**Re: *Comments on Final Title V Operating Permit
Tri-Cities Landfill Energy Facility
Permit # SR-ROP 05-03***

The purpose of this letter is to provide comments on the Final Title V Operating Permit and request additional clarification on permit requirements, as described in detail below.

**Stack Exhaust Intake for the
Gas Analyzer Readings**

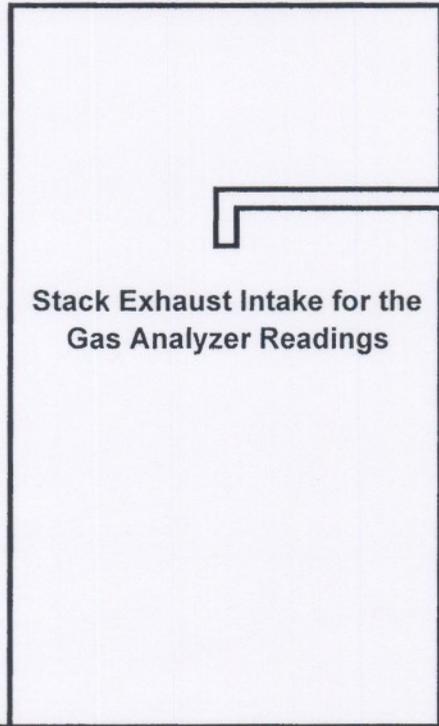
The permit requires that the Tri-Cities Landfill Energy Facility (TCLEF) conduct quarterly monitoring of the carbon monoxide and oxygen concentration from ENG1, ENG2, ENG3, and TO1 using a portable carbon monoxide analyzer. While this permit condition does not explicitly state where the sample should be taken from, Salt River Project (SRP) intends to take the samples at the test port location in the stack. However, in order to avoid renting equipment that would be required to sample at this height, SRP is proposing a different sampling method in which a pipe is run from the inside of the stack out through the test port down to the ground where the measurement will be taken (refer to Figure 1 attached). It is important to note that the portable analyzer does create a suctioning effect that will pull exhaust gas through the sampling tube. Therefore, the concentration measurements should be the same at either sampling location.
